APPEAL SUMMARY

Appeal ID: 20526	Project Address: 6521-23-25 SE 78th Ave
Hearing Date: 6/12/19	Appellant Name: Gerry Engler
Case No.: B-018	Appellant Phone: 503-227-0440
Appeal Type: building	Plans Examiner/Inspector: John Stelzenmueller, David Bartley
Project Type: commercial	Stories: 2 Occupancy: R-2 Construction Type: V-B
Building/Business Name:	Fire Sprinklers: No
Appeal Involves: Erection of a new structure	LUR or Permit Application No.: 17-135775-CO
Plan Submitted Option: pdf [File 1]	Proposed use: 3 attached townhouses

Appeal item 1

GA FILE NO. WP 3110

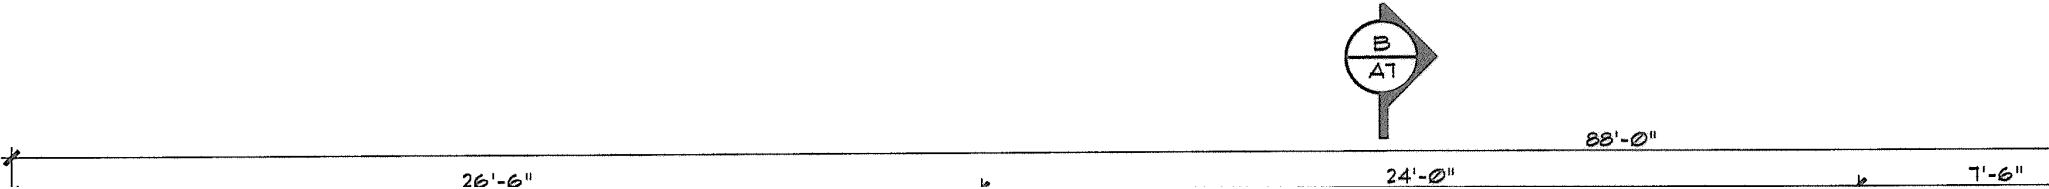
Code Section	OSSC 2014 302.1.502, 708.4 and 718
Requires	The commercial code sections per OSSC 2014 302.1.502, 708.4 and 718 require 13R fire sprinklers in a R2 occupancy.
Proposed Design	<p>We are asking to revise the original permit from the commercial permit error to the townhouse project by simply adding 2-hour fire partitions per the attached 2-hour wall details and delete the sprinklers.</p> <p>The commercial code sections per OSSC 2014 302.1.502, 708.4 and 718 require 13R fire sprinklers in a R2 occupancy. We should be allowed to do a revision to the approved commercial permit to use ORSC 2014 code section R302.2, 2 & 3. We can use the 2-hour fire partition walls allowed in a townhouse project to eliminate the fire sprinklers and hydrant.</p>
Reason for alternative	<p>Owners/Applicants Narrative RE: code appeal.</p> <p>6521-23-25 SE 78th. Permit 17-135775-000-00-CO</p> <p>Request: To qualify/build the party walls between the units as 2-hour walls and eliminate the fire sprinkler system.</p> <p>This appeal should be granted since the issue was is merely been created by paperwork and is not a real deviation from the code.</p> <p>The 2011 Oregon Residential Specialty Code (the code at the time this plan was submitted for building permits) has a definition for a Townhouse and this project fits that definition.</p> <p>Section R.302.2.2 & 3 allow construction without a fire sprinkler system if the units are separated by a 2-hour wall. This unit contains a 2-hour wall based on the design and layers of drywall but it is mis- labeled a 1-hour wall. (WP 3110) A diagram of a 2-hour wall is attached (UL U334) and our diagram exceeds the specifications of that wall even though our wall in the plan is called out a</p>

1-hour wall. We propose building UL U334.

- City stamp from plan excerpt of a similar 3-unit building.
- Plan excerpt. Detail WP 3110
- Wall detail UL U334

Change of permit type from commercial to residential: Denied. Proposal does not provide equivalent Life Safety protection.
